# Work Order ID 124514

Item Name: Filler

**From:** Pablo Bravo  
**Sent:** October-09-14 12:17 PM  
**To:** Alex Pharand  
**Cc:** Jean-Luc Menard  
**Subject:** RE: 646.3610 Deviation

646.3610

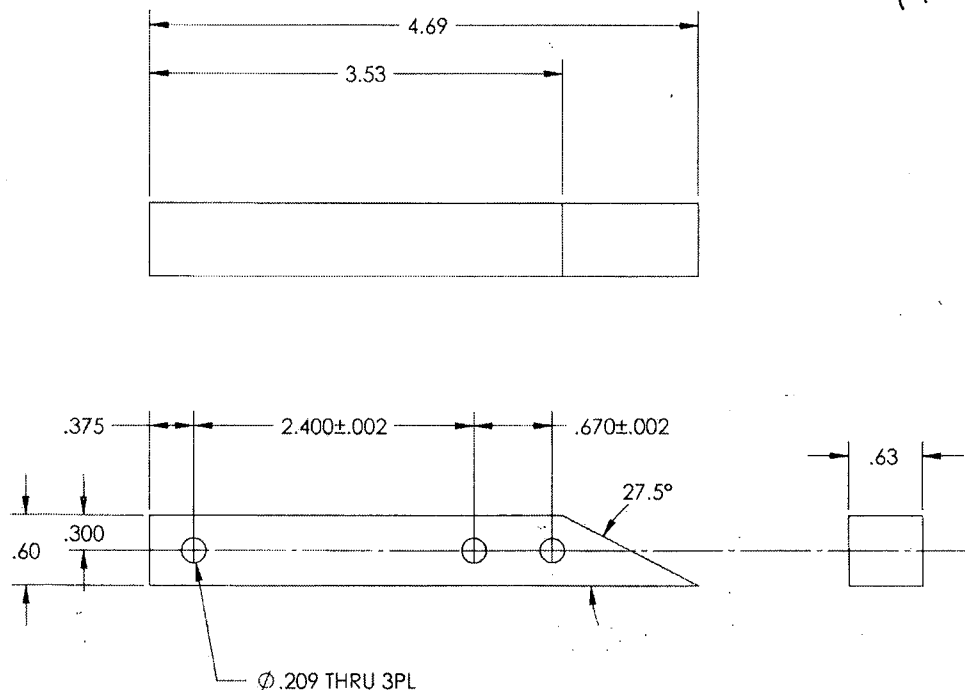
Root Cause	Date	Step	Qty	Description of work order update or non-conformance	Initial Chief Eng	Action Description	Sign & Date	Verification	QC Inspector
Design	14/10/09	110	2	The length (4.64) is too short (4.652). Error when making the angle 27.5°.	A.P. 14.10.09	SEE ATTACHED	J.C.-L 14/10/09	DAS 40 9-89 14/10/14	DAS 16 9-89 14/11/12
Doc/Data									
Equip/Tooling									
Handling/Pre									
Material									
Operator									
Offset/Setup									
Process									
Supplier									
Training									
Transport									
Unapproved

See attached DWG. Dim 4.69 is actually 4.652, scrap or no scrap?

The part should be okay to use as-is. I imagine that the issue was when making the bevel cut?
